SITE PLAN

PROJECT NAME:
 CAPPS, HODGES & MORGAN
CASE NUMBER: SP2022-009.

CAPPS, HODGES & MORGAN
1200 SUMMER LEE DRIVE
ROCKWALL, TX 75032
SP2022-009

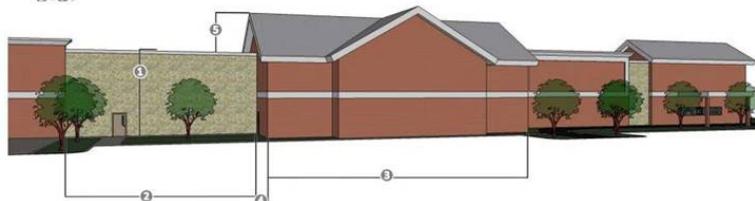
- Entrance on Summer lee. **Noted**

3 **SOUTHEAST BUILDING EYE LEVEL PERSPECTIVE - SIGHT LINE STUDY**

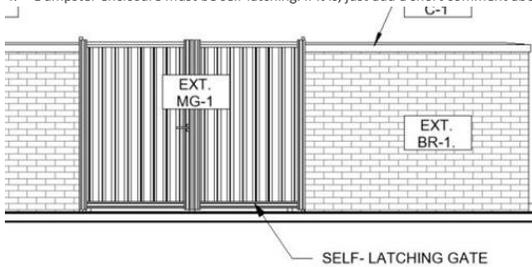
3. RTU's need to be screened **OR** provide a roof plan and site line study to verify the RTU is not visible from ground level. **On sheet A1-4.0 we have these views from both street sides showing that the RTUS are not visible at eye level.**

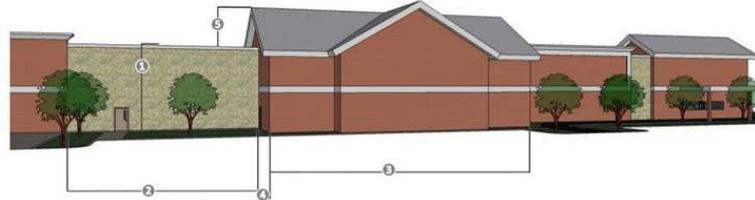
- Entrance on Summer lee. **Noted**
-
